16 October 2020

RE: PROPOSED BATTERY ENERGY STORAGE SYSTEM FOR THE HUMANSRUS 2 SOLAR PV ENERGY FACILITY ON THE FARM HUMANSRUS 147 NEAR PRIESKA, NORTHERN CAPE

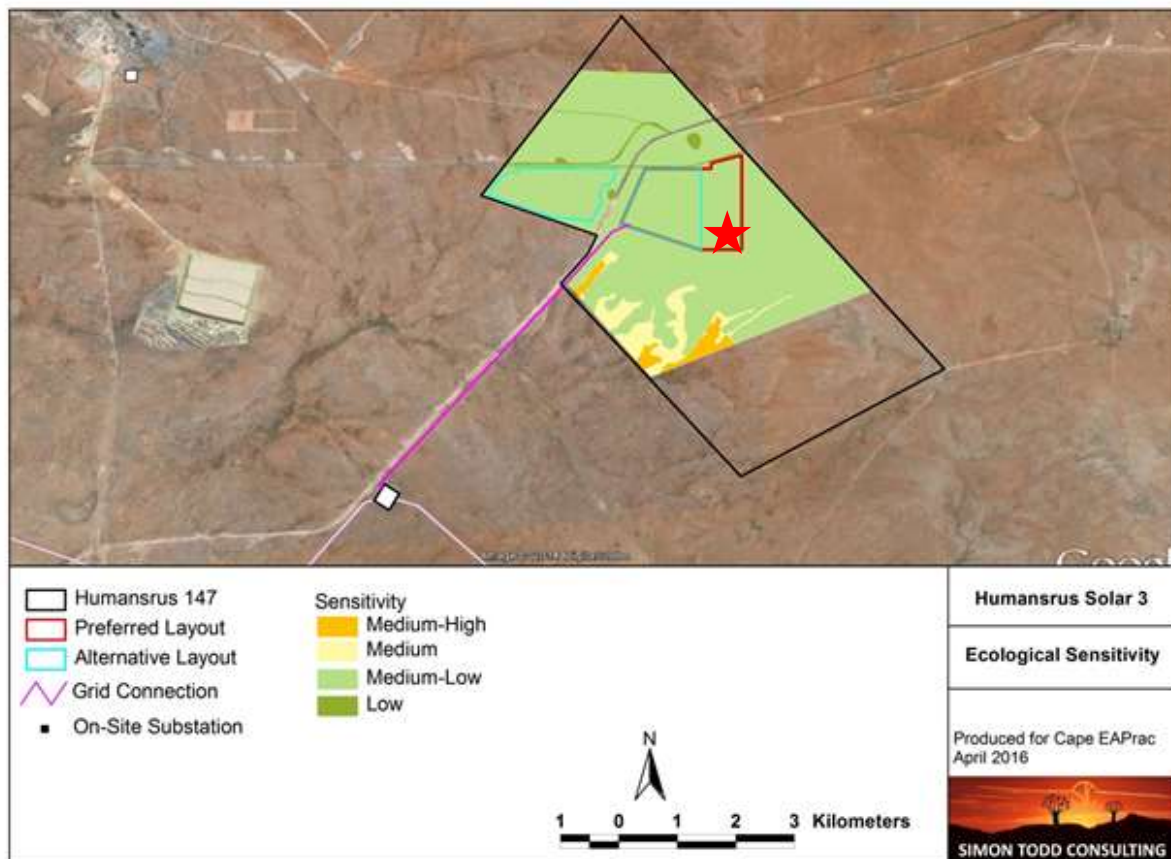
The location of the BESS within the previously assessed footprint area of the project as shown in the image below. The BESS is located within a medium - low sensitivity area with no features of concern in close proximity to the BESS.

In the original ecological assessment, it was assumed that the habitat within the facility would be largely lost in its entirety to the development. As such, the addition of the BESS within the assessed footprint would not increase direct habitat loss. In terms of additional risks, there do not appear to be any significant additional risks to ecology associated with the BESS. The original impacts associated with Humansrus Solar 3 are illustrated in the Table below.

Based on the footprint and technical specifications of the BESS as provided for this statement, there are no changes to the assessed impacts that are warranted based on the inclusion of the BESS into the Humansrus Solar 3.

No additional mitigation measures or changes to the EMPr mitigation measures would be required in terms of this amendment, as no significant change to impacts or new impacts will occur. All the original avoidance and mitigation measures as indicated in the original botanical and faunal study are still relevant and applicable to the amended layout and must be implemented.
